TRAPPERS RIDGE AT WOLF CREEK P.R.U.D. PHASE 7A

LOCATED IN THE NORTHWEST QUARTER OF SECTION 26,
TOWNSHIP 7 NORTH, RANGE 1 EAST, SALT LAKE BASE AND MERIDIAN,
WEBER COUNTY, UTAH
MARCH 2017

TRAPPERS RIDGE PHASE 7

CONSTRUCTION DOCUMENTS EDEN, WEBER COUNTY, UTAH

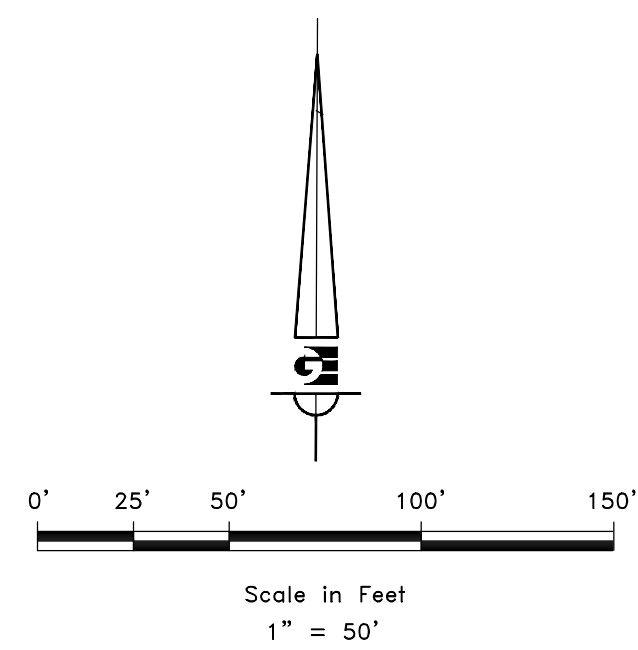
The written narrative shall contain the documentary, parcel, and tangible evidence used in establishing the location of the lines of the survey. WCO 45-3-4(a).

The existing location, widths, and other dimensions of all existing or platted buildings within and immediately adjacent (within 30') to the tract to be subdivided. WCO 106-1-5(a) (6)

The existing location, widths, and other dimensions of all existing or platted streets within and immediately adjacent (within 30') to the tract to be subdivided. WCO 106-1-5(a)(6)

Permanent street monuments shall be accurately set at points necessary to establish all lines of the street. Centerline monuments shall be noted on the final plat. WCO 106-4-2(g) & WCO 106-1-8(c)(1).

TRAPPERS RIDGE AT WOLF CREEK P.R.U.D. PHASE 7B

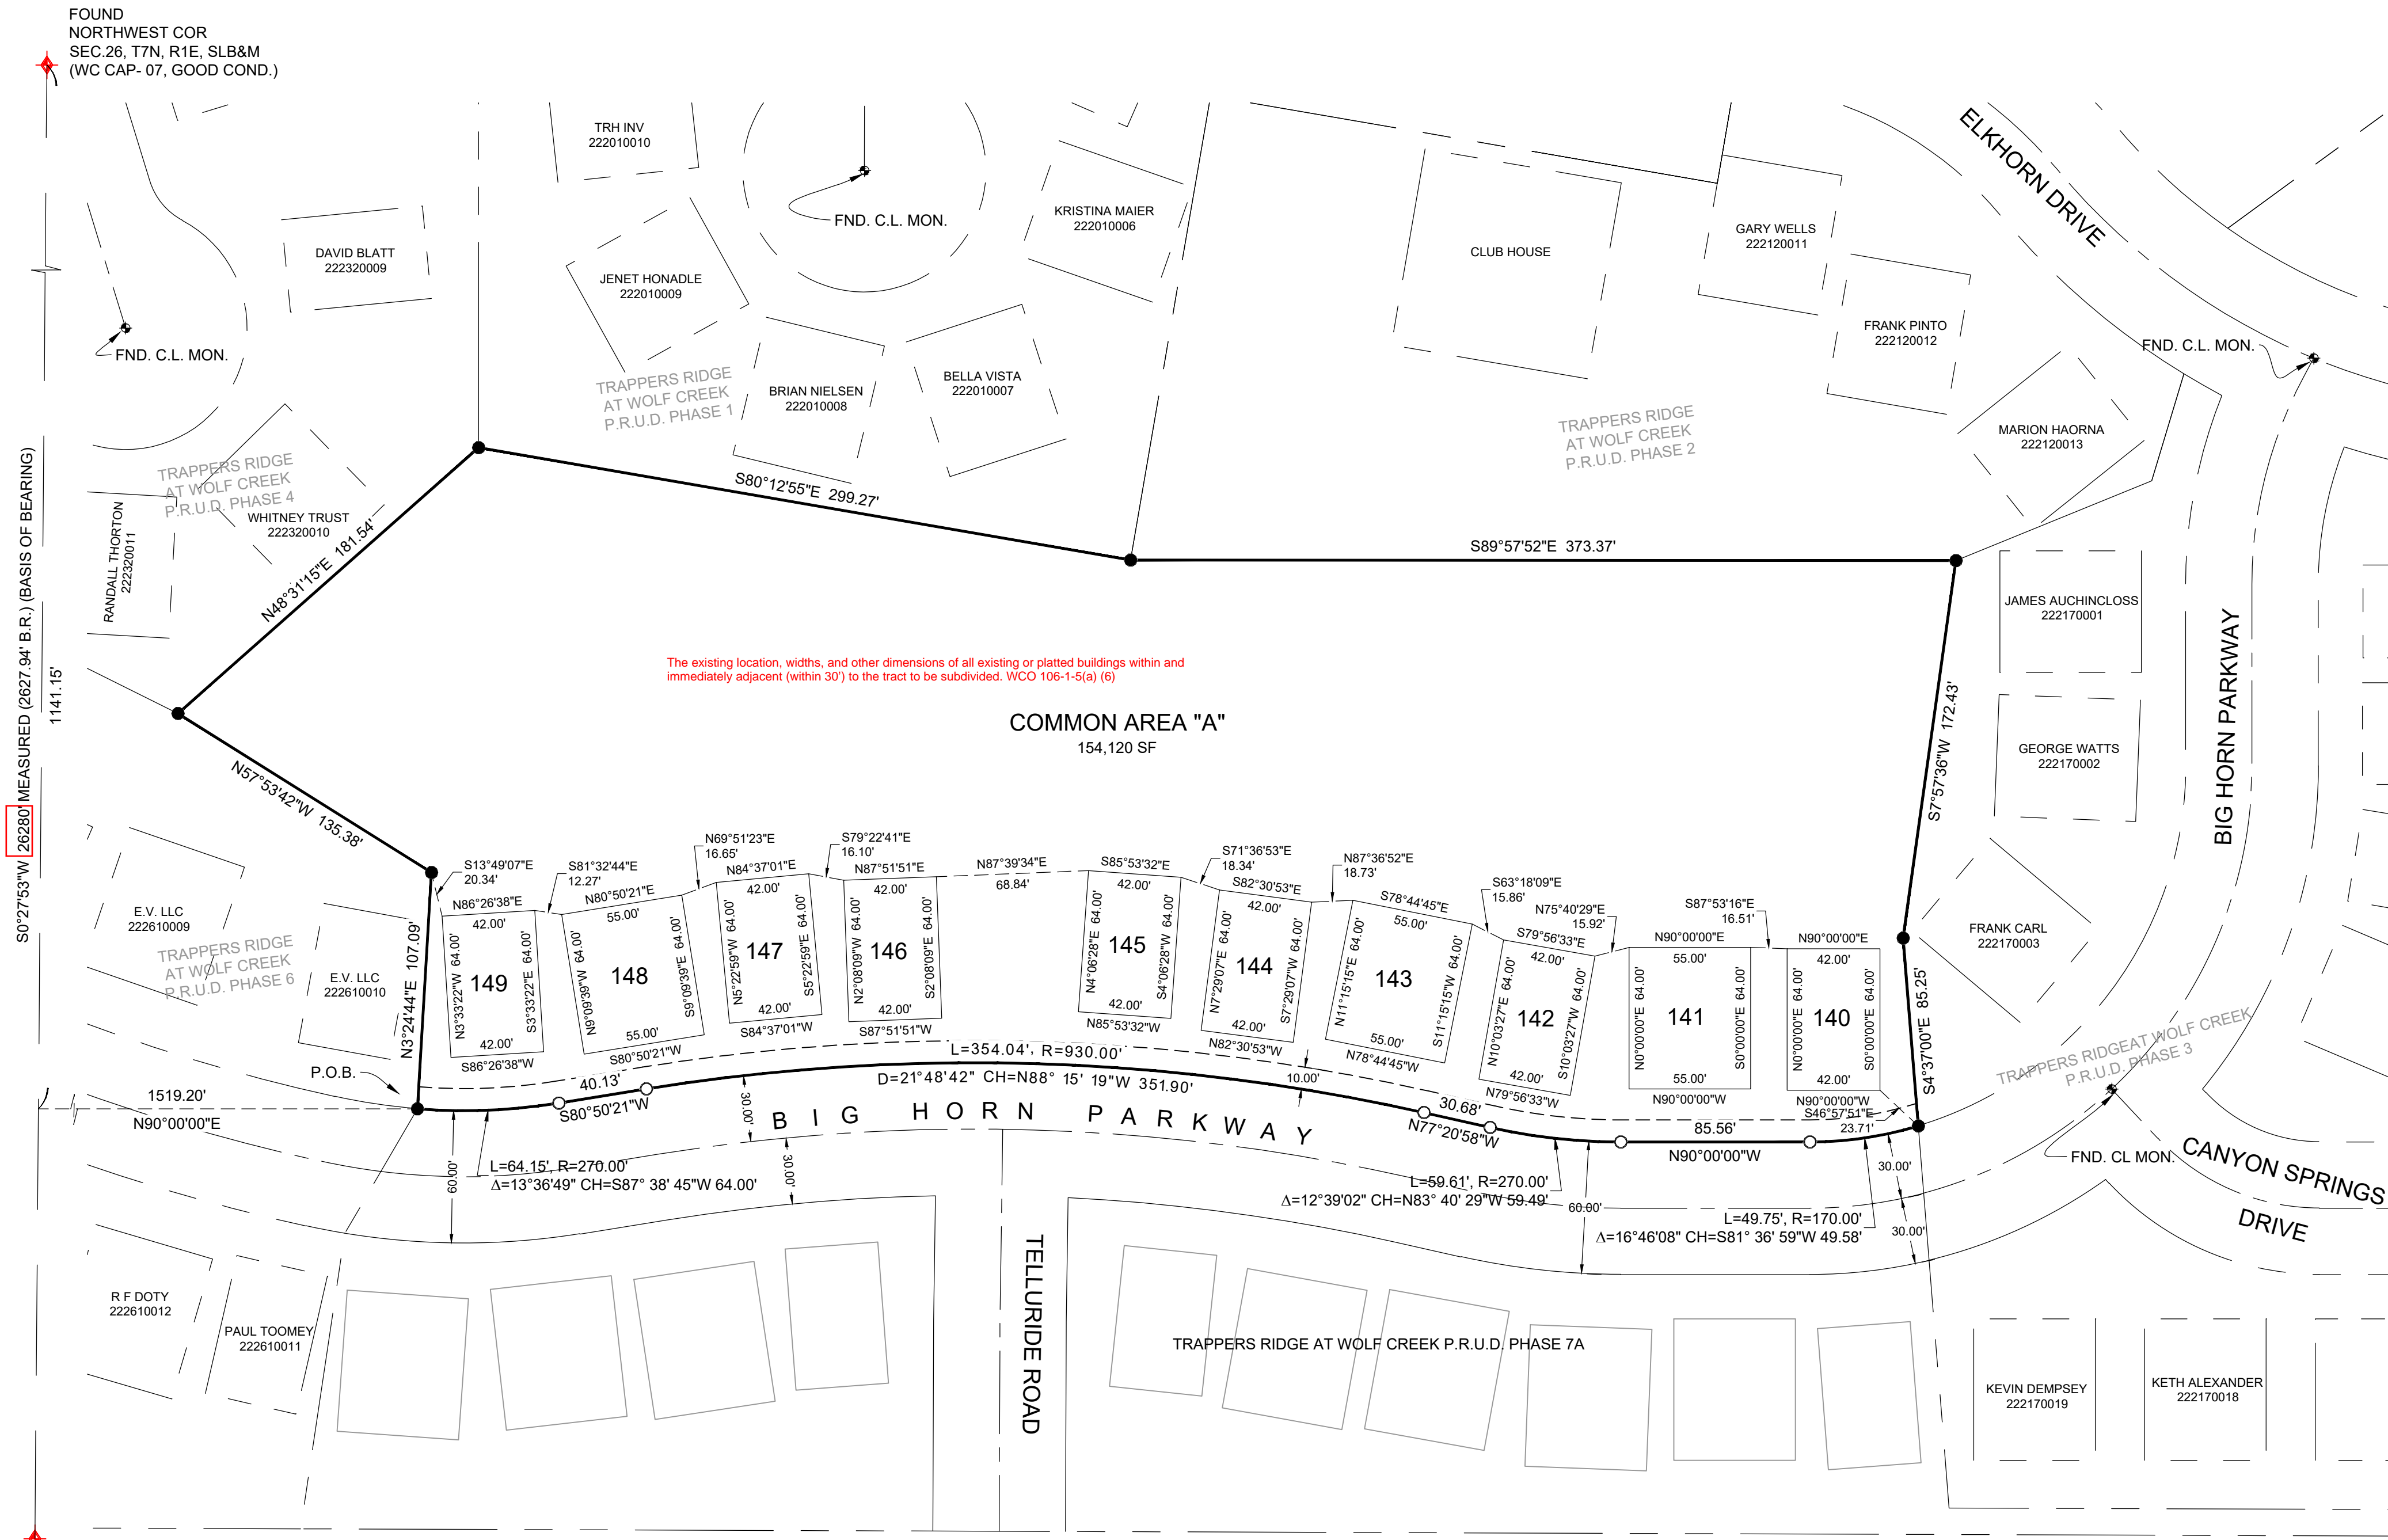
The plat shall have a detailed description of all monuments found and each one shall be referenced on the plat including the type, size, condition, and location in reference to the surface of the ground as well as a description or graphic depiction of the markings, date, agency, entity, or surveyor as inscribed on the monument. WCO 45-3-33(b)

The written narrative shall contain the documentary, parol, and tangible evidence used in establishing the location of the lines of the survey. WCO 45-3-3(a)

The existing location, widths, and other dimensions of all existing or platted buildings within and immediately adjacent (within 30') to the tract to be subdivided. WCO 106-1-5(a) (6)

The existing location, widths, and other dimensions of all existing or platted streets within and immediately adjacent (within 30') to the tract to be subdivided. WCO 106-1-5(a)(6)
